LAUREATE PARK JEWEL BOX

SUMMARY

<p>Owner Robert B. Adams Lake Nona Land Co., LLC</p> <p>Applicant Heather Isaacs Tavistock Development Co., LLC</p> <p>Project Planner Colandra Jones, AICP</p>	<p>Property Location: The subject property is located north of Tavistock Lakes Boulevard, west of Narcoossee Road, and south of Central Florida Greenway (SR 417). (±4.5 acres, District 1).</p> <p>Applicant's Request:</p> <ol style="list-style-type: none"> 1. Specific Parcel Master Plan (SPMP) Amendment for the Laureate Park Phase 6 residential development. The amendment introduces a new lot type, the Jewel Box product. The project is comprised of 40 detached single family units. Also, revise the lot type mix. 2. Major Subdivision Plat to create the preliminary plat for 40 residential lots in Phase 7A of Laureate Park. 	<p>Staff's Recommendation: Approval of the request, subject to the conditions in this report.</p>
<p>Updated: November 24, 2015</p>

DEVELOPMENT PLAN/PRELIMINARY PLAT

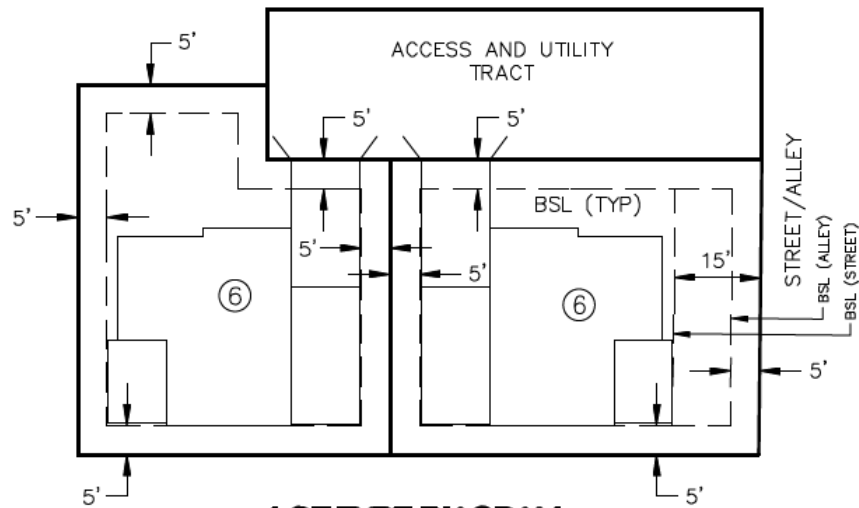
Each lot shall have a minimum 10 foot frontage on a street or open space tract. Lots 176-178, 201, and 202 shall be re-configured to address this requirement.

5. A pedestrian connection shall be installed across the alley, linking Tract OS-11 to the parking area and pass between lots 201 and 202 to connect OS-12 together. The parking shall be split into two areas with the walkway between. A sidewalk shall also be installed in front of the parking area, allowing access to the network.

ROAD CROSS SECTIONS

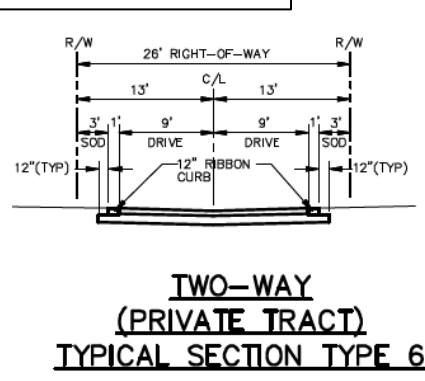
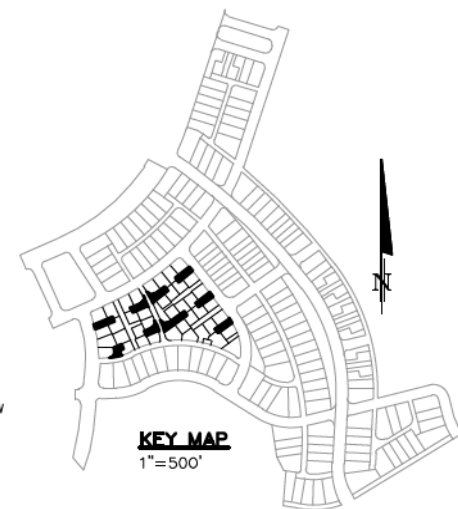
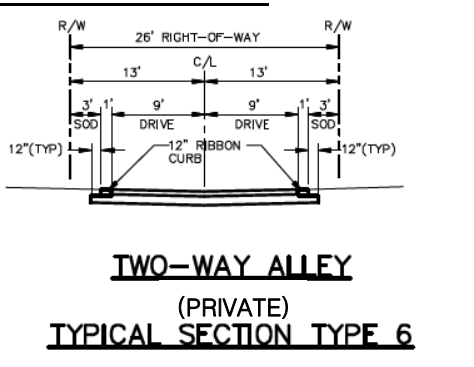
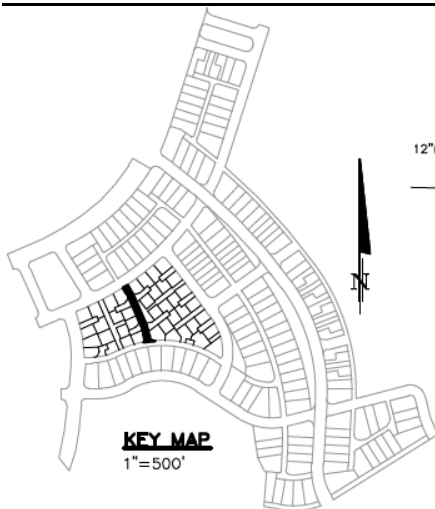
The proposed roadway cross section needs to be consistent with the approved Master Plan.
